Dear Reviewer,

"A machine learning based approach for better prediction of fatigue life of offshore wind turbine foundations using smaller datasizes" (https://doi.org/10.5194/wes-2025-173)

Figure 2: Comparison of wave height measurements (top) and wave period measurements (bottom) from 9MW OWT location and Thorntonbank buoy

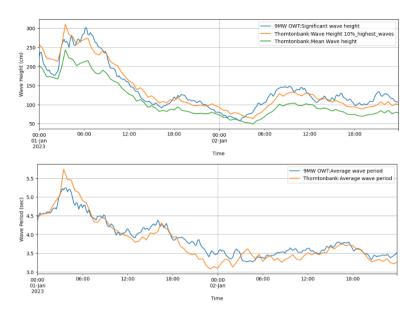
1) In your work, you use SCADA and wave data for the extrapolation. Surely, SCADA should always be available. However, wave data might not always be available or at least not for the precise location (or close to it). Perhaps, you can briefly discuss how far away from the turbine the wave measurements can be conducted to be still useful.

For wave-related parameters, measurements were taken from the Thorntonbank South buoy, located 18.5 km from the 3 MW turbine and 7.8 km from the 9 MW turbine. Although some differences in wave amplitude exist between the buoy and local measurements, the overall trends are consistent. Since the extrapolation models primarily rely on capturing these broader trends rather than values, the buoy data remain suitable for the extrapolation task. It does raise some concern when as-designed wave conditions, rather than wave distributions taken from the measurement station, would be used for the extrapolation. In such a scenario, the transformation needs to be properly checked.

More generally, the acceptable distance between wave measurements and a turbine depends on local bathymetry, wave climate, and directional spreading. Nonetheless, we acknowledge that in sites with strong spatial gradients, closer wave measurements would be necessary.

"The distance between the turbine and the wave measurement buoy leads to some differences in wave parameters compared with measurements taken closer to the 9~MW turbine, although the overall temporal trends remain consistent. However, the acceptable distance between wave measurement station and a turbine depends on local bathymetry and wave climate, and closer measurements may be required in areas with strong spatial gradients."
